I object to the Beaches Link as presented in the EIS due to the following:

BL EIS Appendix F, Annexure B (Figure 1) shows that just 25% of BL traffic is expected to use the western link through Artarmon. The Warringah Freeway-Gore Hill Freeway has the capacity for this traffic.

Figure 26 – Temporary cyclepath to Cleg St

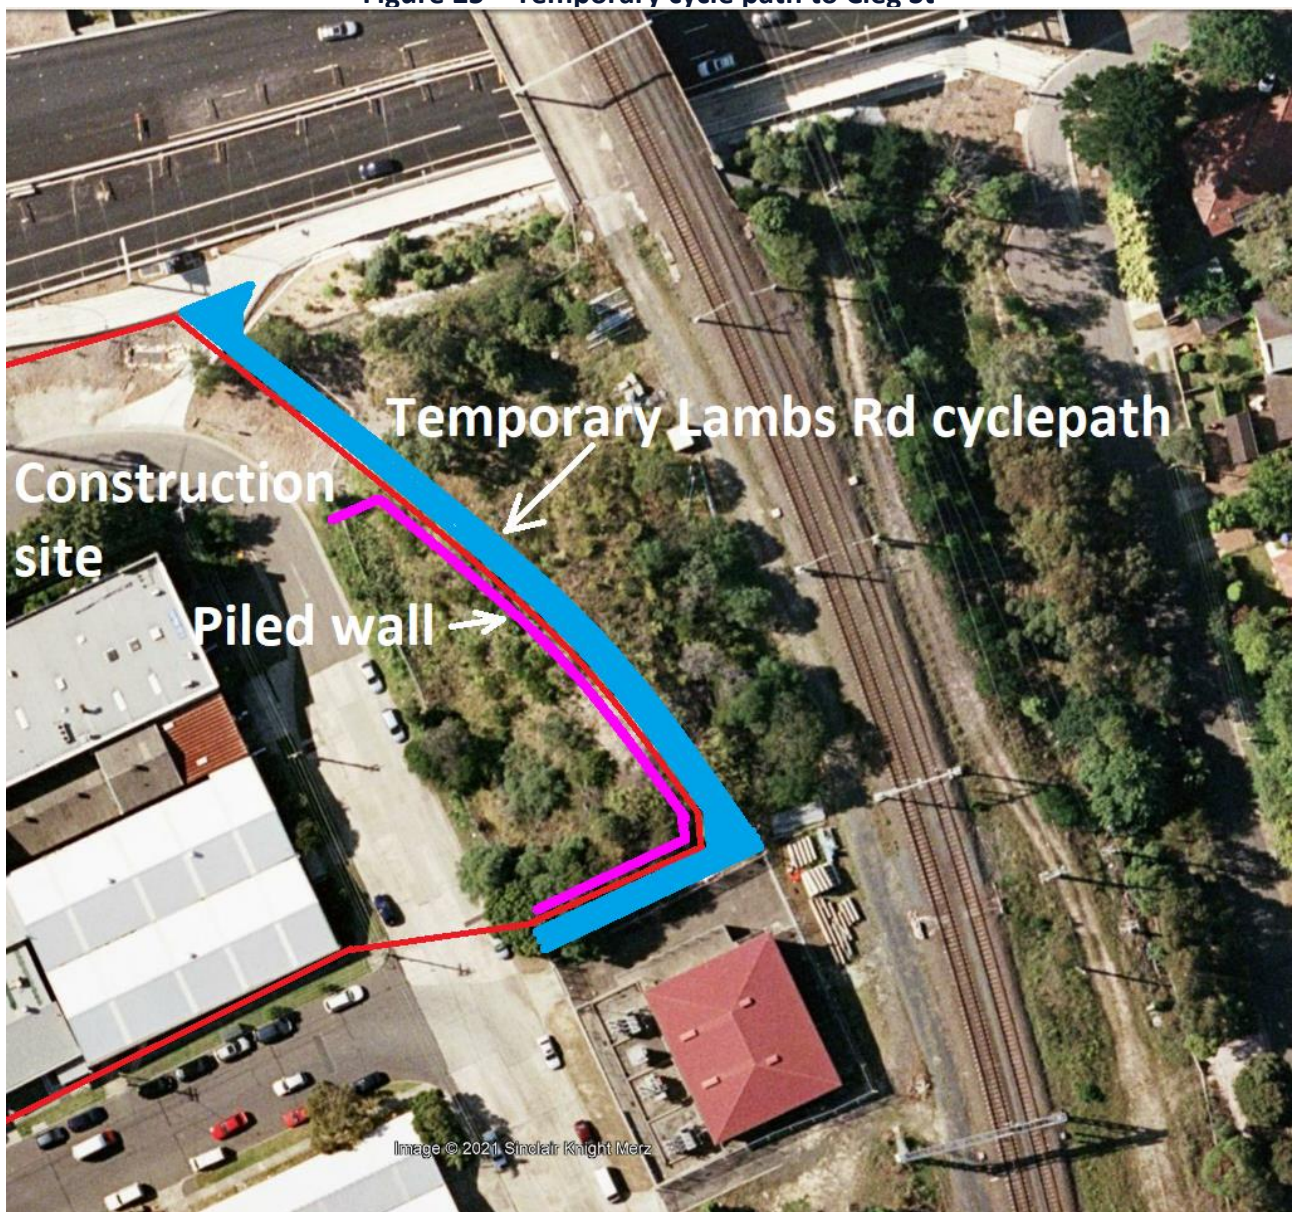
The Station St/Francis St route proposed in the EIS has a 30-metre rise in height from the Flat Rock Creek crossing to the Lambs Rd railway overpass – much of this at a 10% grade. A better location for a temporary cyclepath is along the western side of the railway embankment as illustrated in Figures 25 to 28. This route has an 11 metre height increase at a grade of about 12% over a length of 90 metres.
